Oregon State University  
Construction Contract Administration  
**Path of Travel Improvements 2018**

**ADDENDUM NO. 1**

SHEET TITLE  
**EAST CAMPUS ADA BARRIERS**  
 SHEET #  
**C1.1**

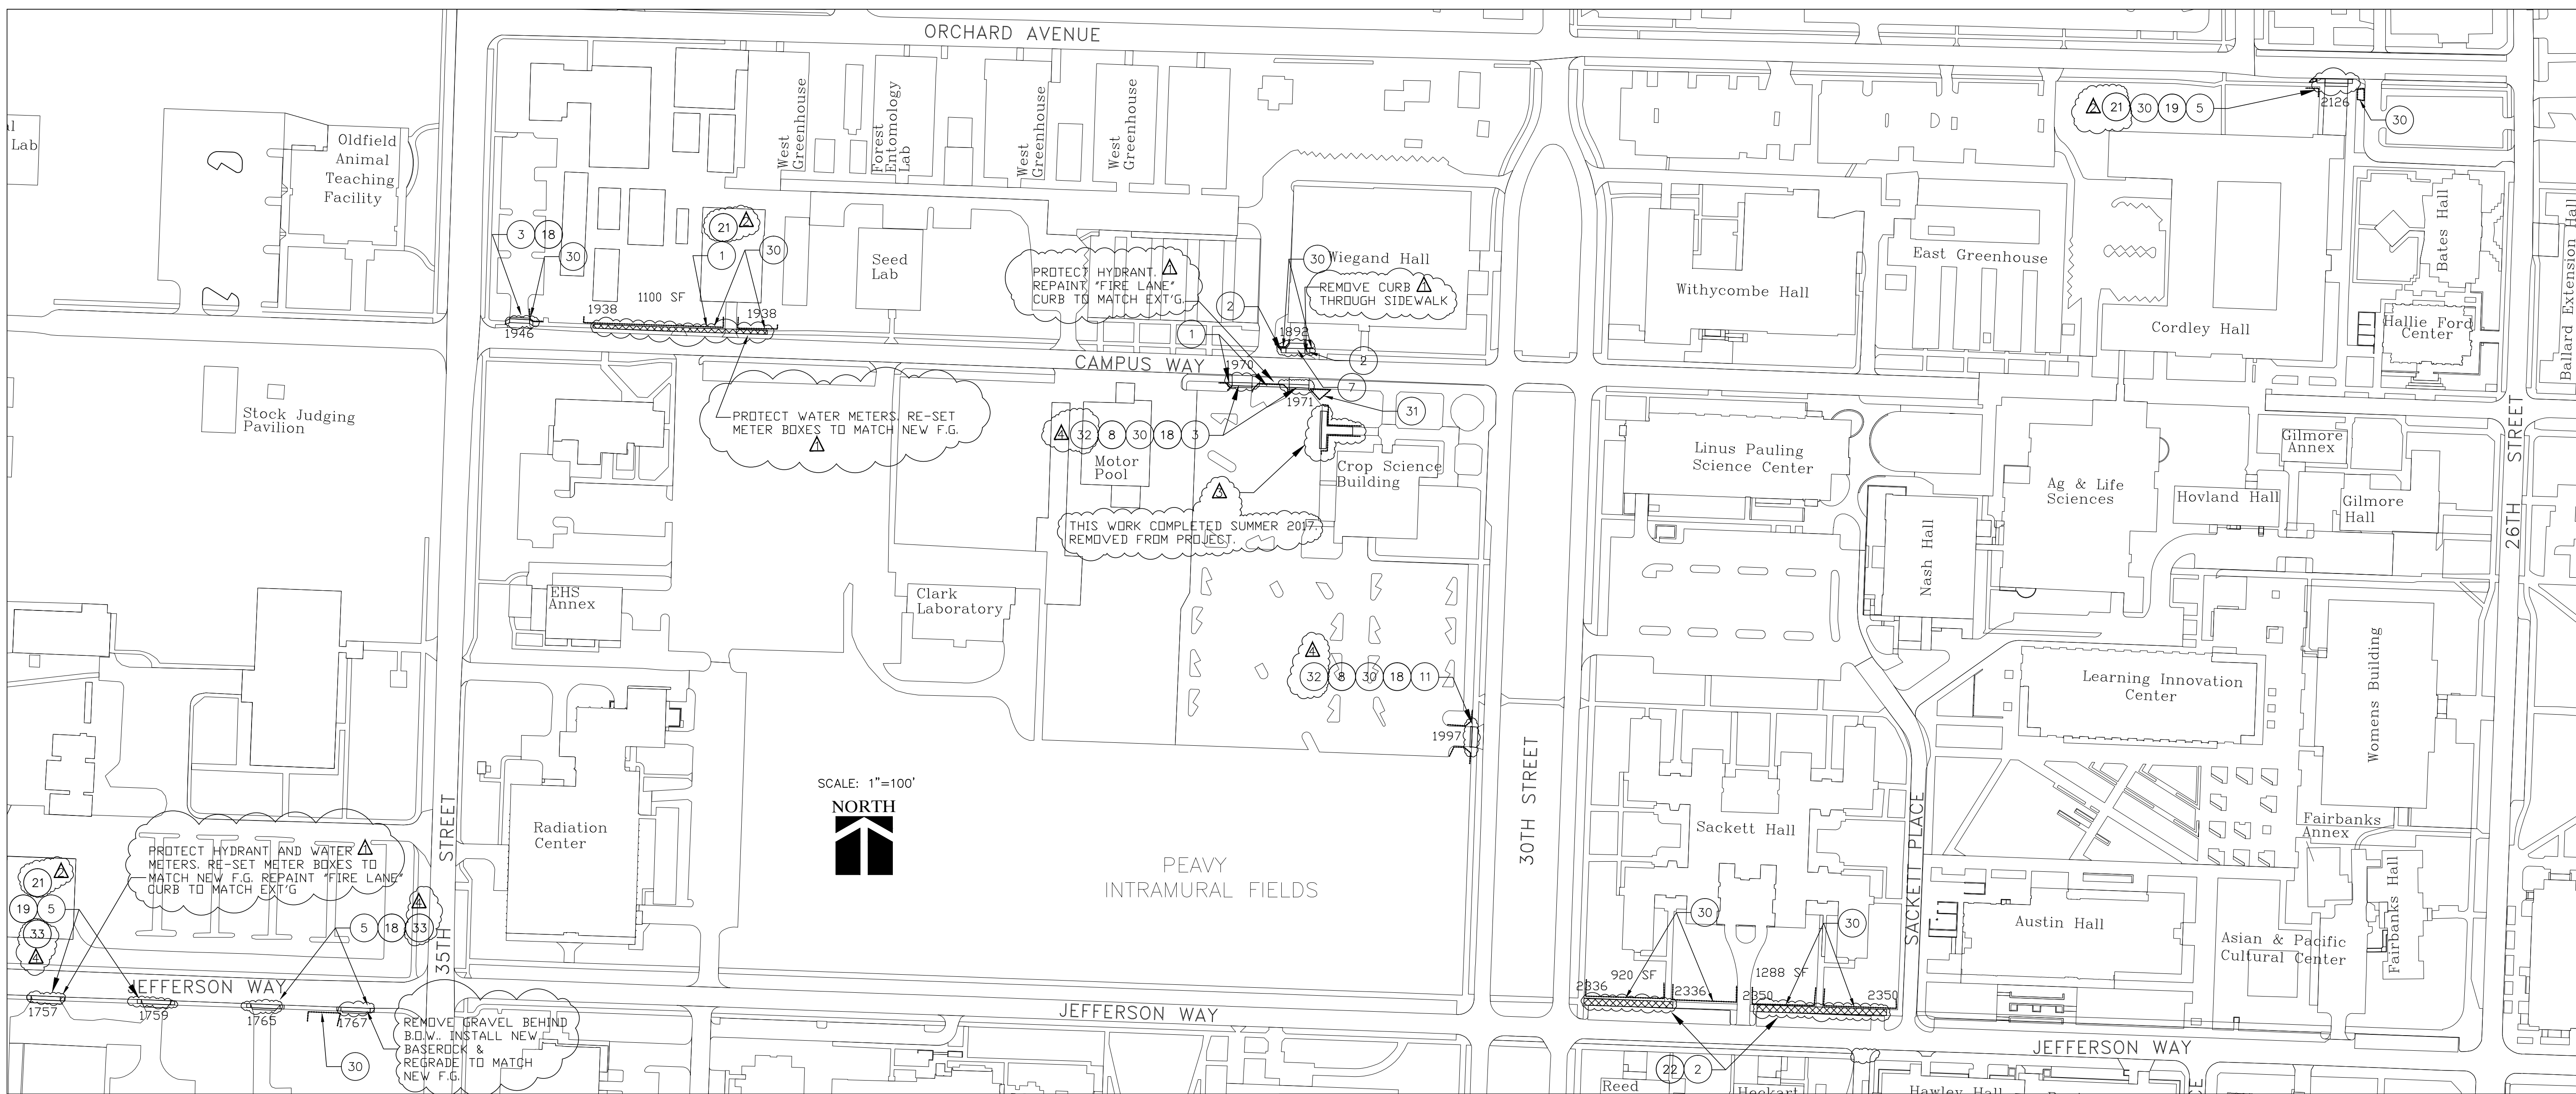
- Item 4                Sheet C1.1 “East Campus ADA Barriers”, REPLACE in its entirety with sheet C1.1, Rev 4 dated 02/13/2018.

**NW CAMPUS ADA BARRIERS**

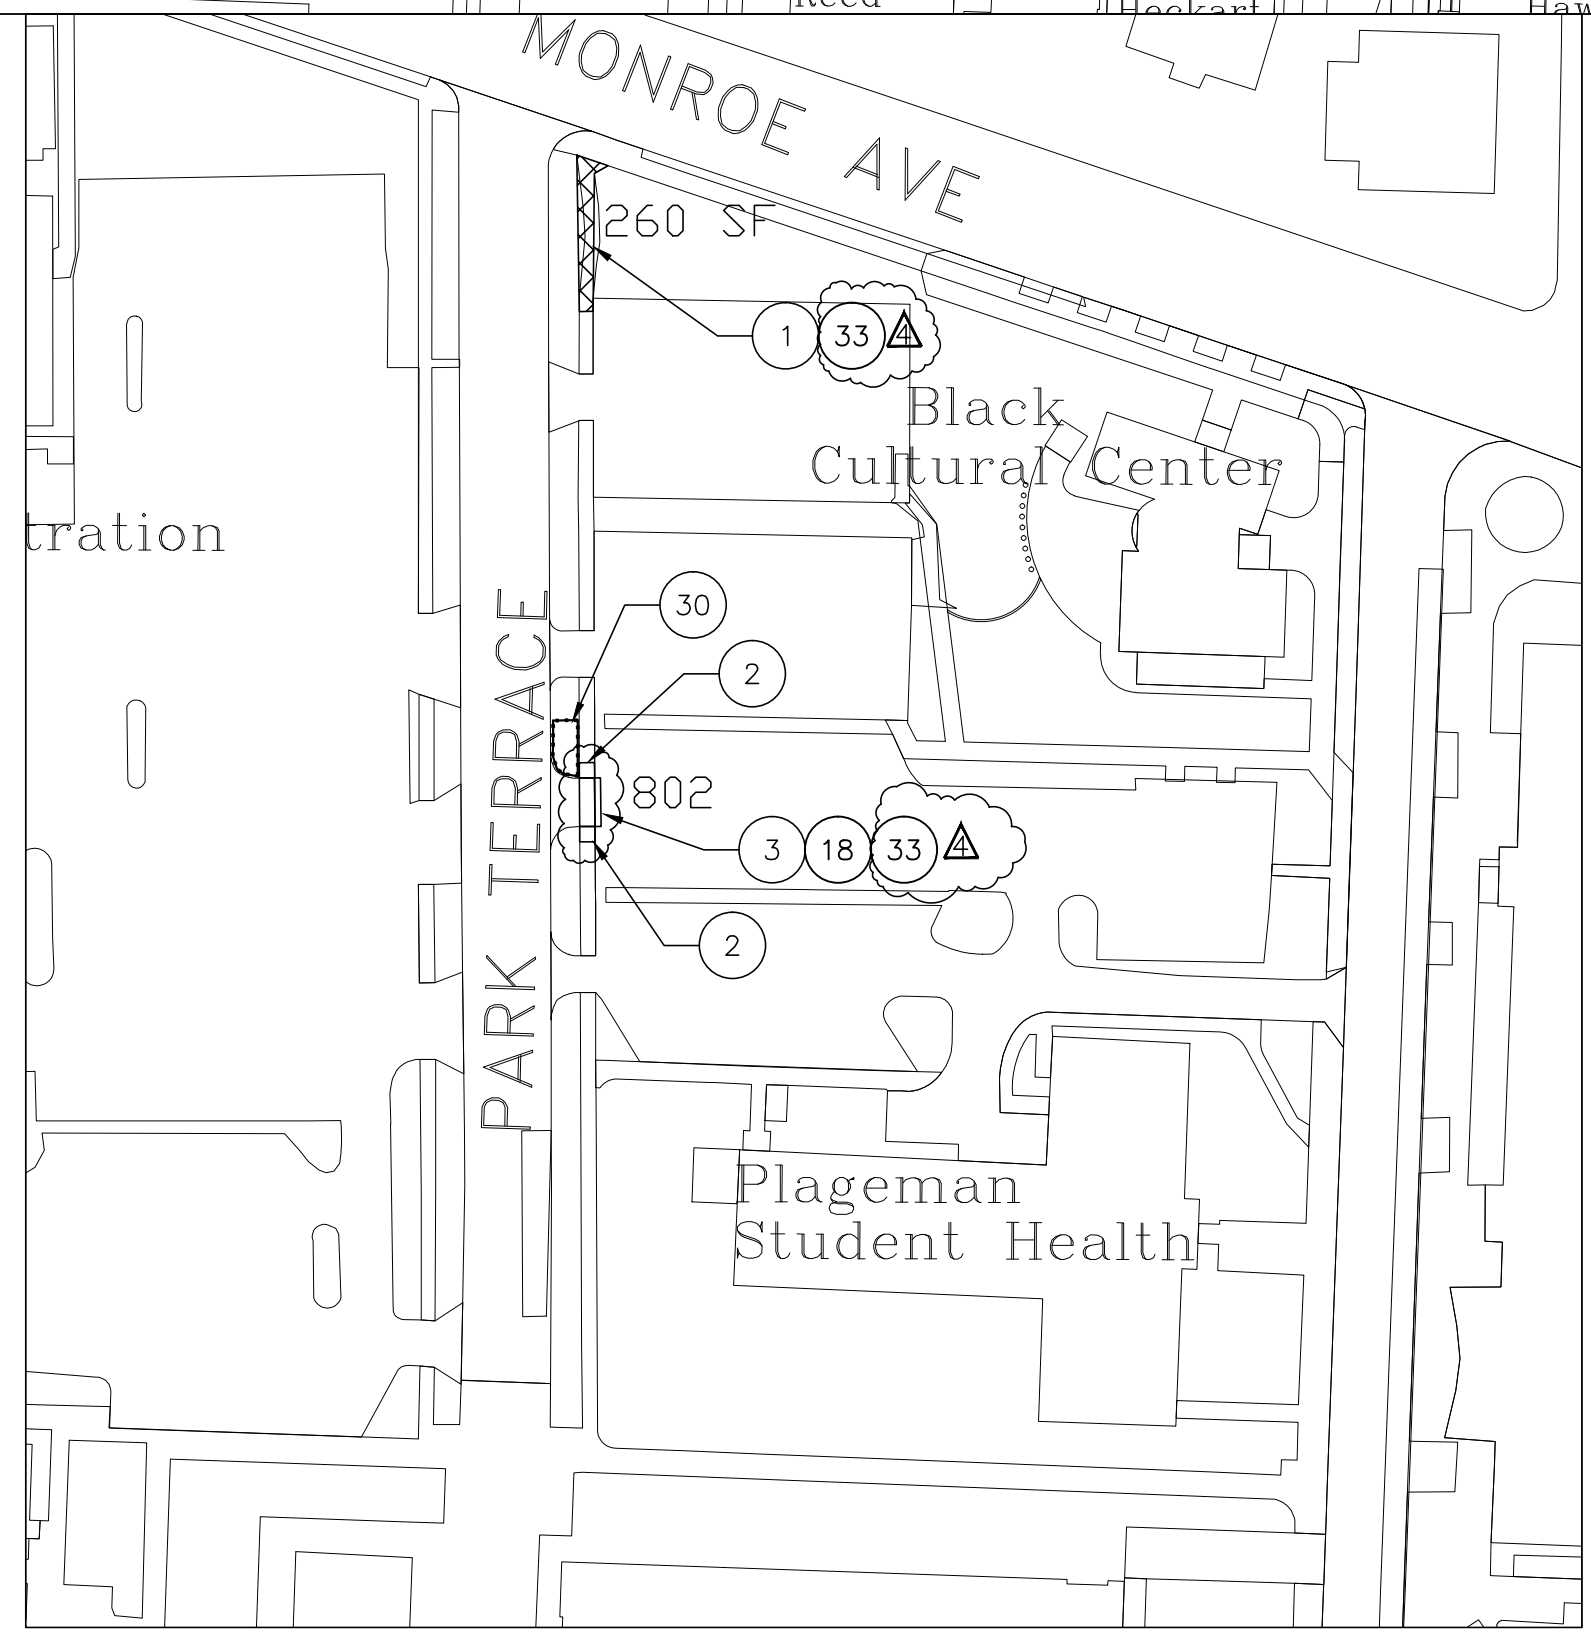
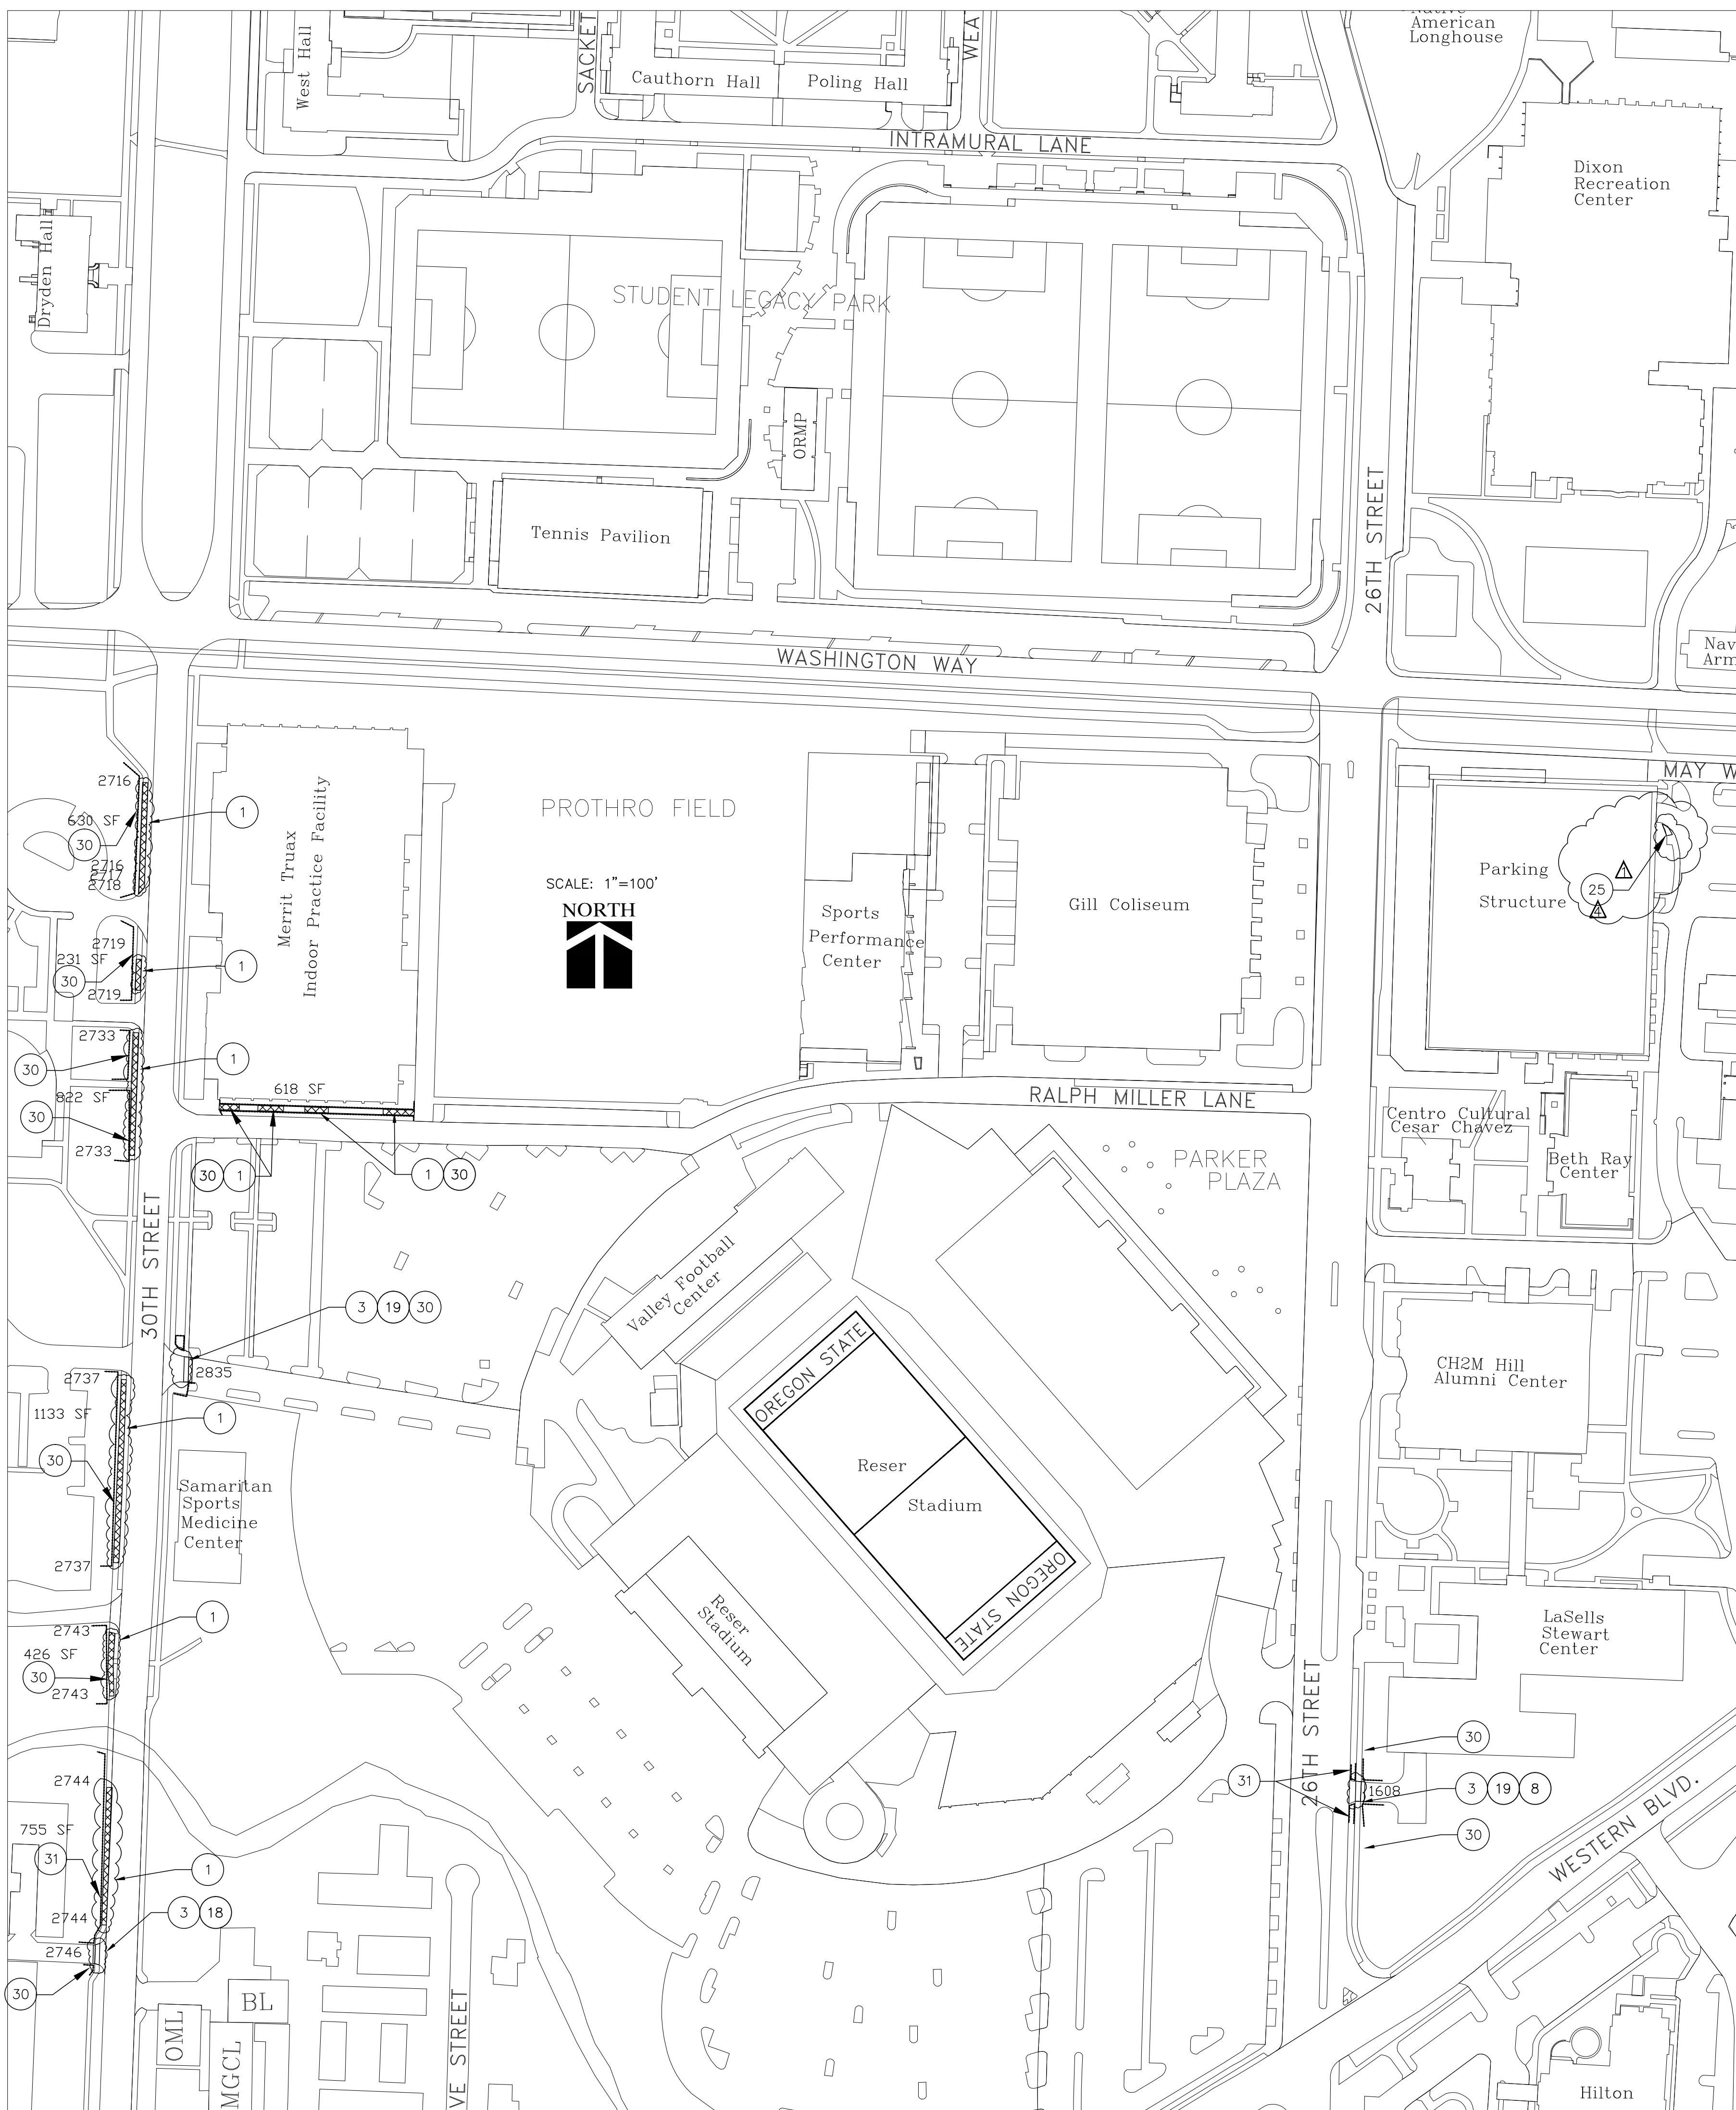
- Item 5                Sheet C1.2 “NW Campus ADA Barriers”, REPLACE in its entirety with sheet C1.2, Rev 4 dated 02/13/2018.

SHEET TITLE  
**SW CAMPUS  
ADA  
BARRIERS**

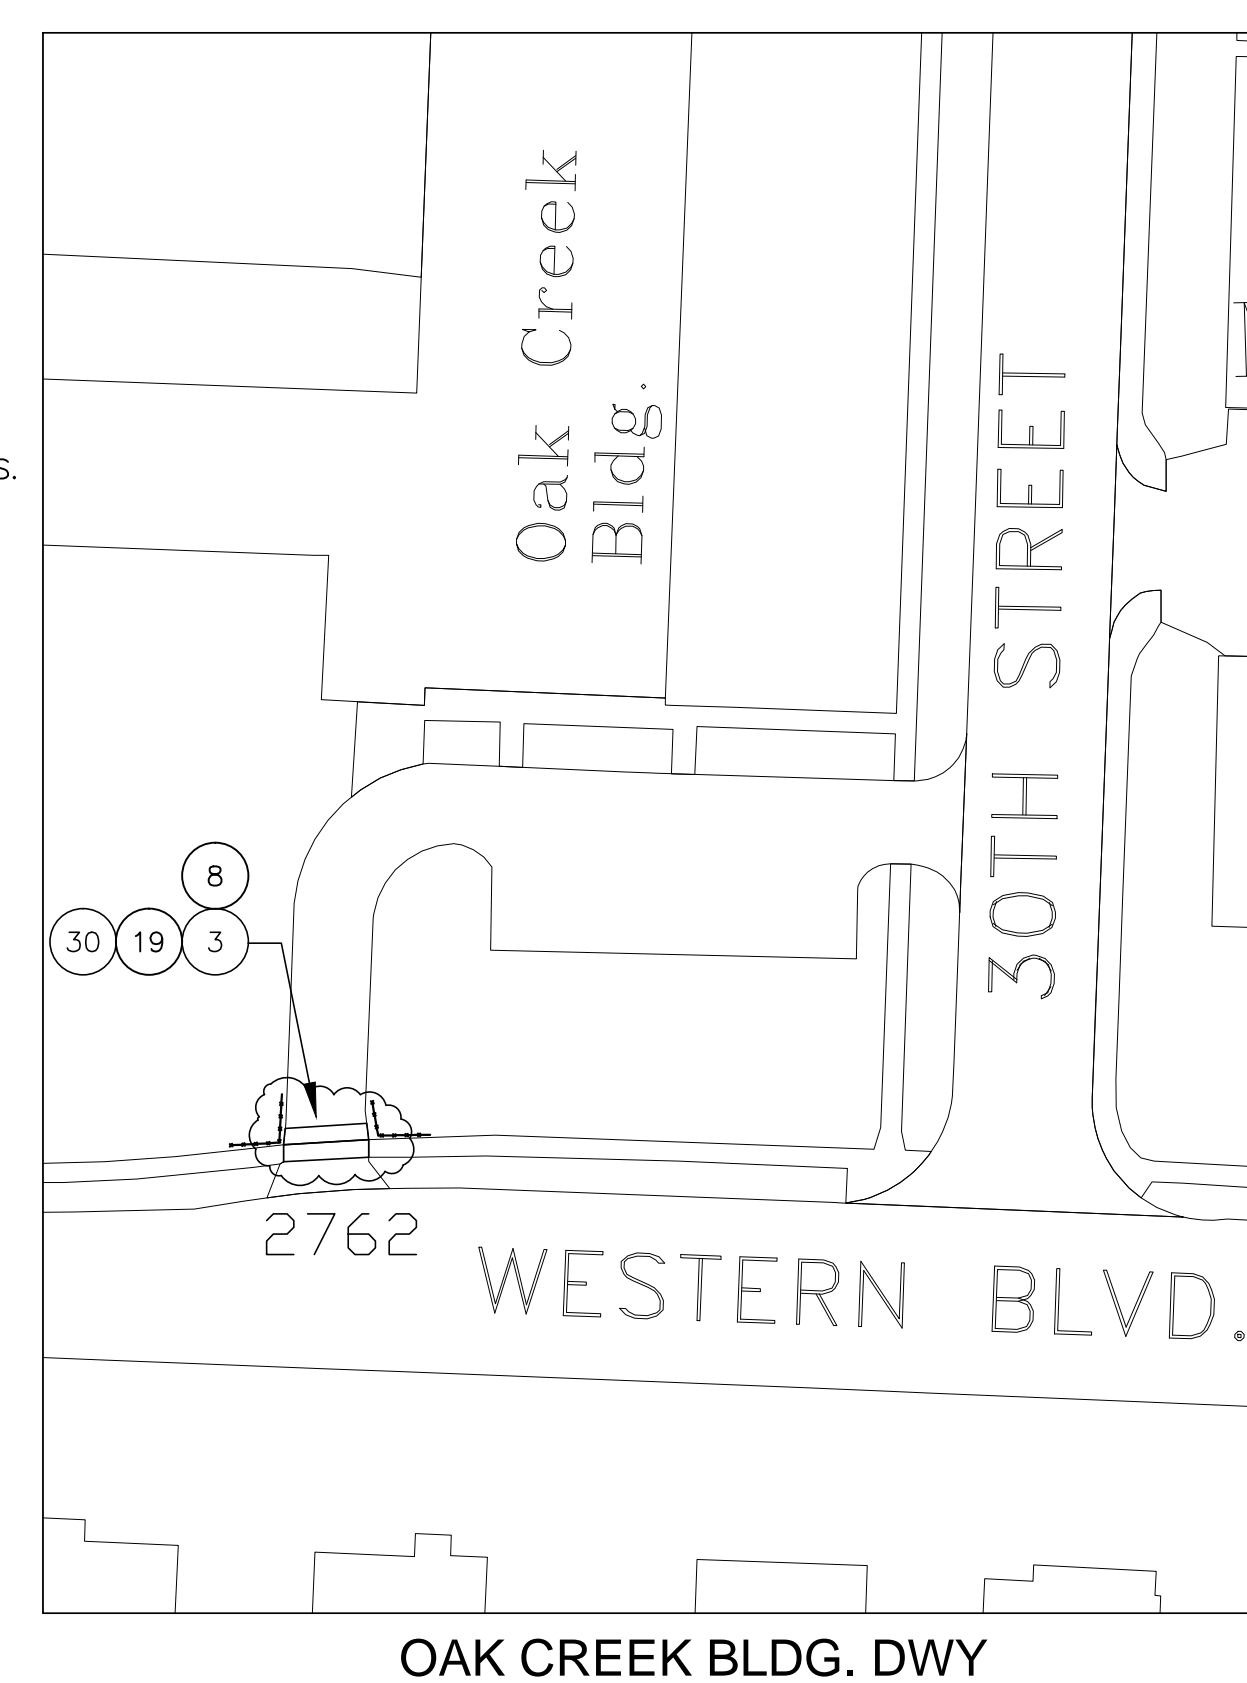
- Item 6                Sheet C1.3 “SW Campus ADA Barriers”, REPLACE in its entirety with sheet C1.3, Rev 4 dated 02/13/2018.
